AMENDMENT TO THE DRAWINGS:

Phone: (216) 621-2234 Fax: (216) 621-4072 Customer No.: 26,294 Serial No. 10/767,634 Amdt. Dated 4-4-06 Reply to Office action of 12-21-05 Annotated Sheet Showing Changes

(w2 Fig. 2 (w2 36a ⊌R2 R1~ (R5) **5369** 36e / -36 /h2 30 --30 h2~ /36c 36b-,34c 34_b hla /h1 -32 32-/34d 34e ¿R4 ⁷34a 34-R3-0 ζ_{W1} l_{w1}

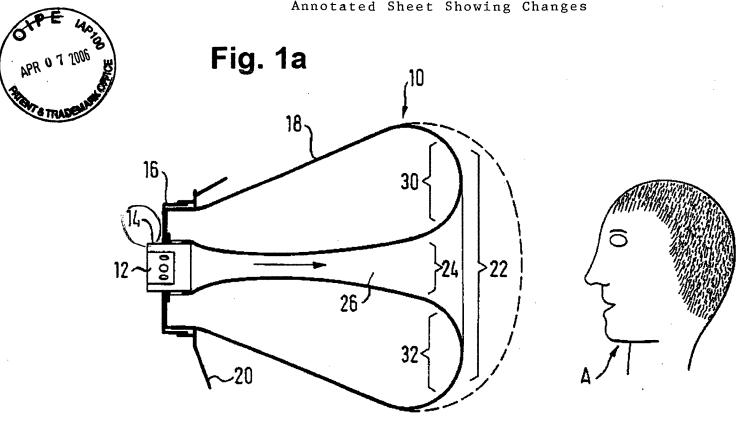
The attached replacement sheet of drawings includes changes to Figs. 1a and 2. Specifically, Fig. 2 is amended to replace the reference numbers "R1" and "R2" with --R5-- and --R6-- for Fig. 2. The lead line for the diffuser in Fig. 1a is corrected. Fig. 3 is added to show the feature recited in claim 3. Annotated drawing sheets showing the changes in red are also attached. No new matter has been added.

Fig. 2 is amended to replace the reference numbers "R1" and "R2" with --R5-- and --R6-- for Fig. 2. Accordingly, the specification is amended to reflect this change to Fig. 2. The lead line for the diffusor in Fig. 1a is corrected. Fig. 3 is added to show the feature recited in claim 3 that the horizontal width of the upper region is greater than the horizontal width of the lower region. This feature is
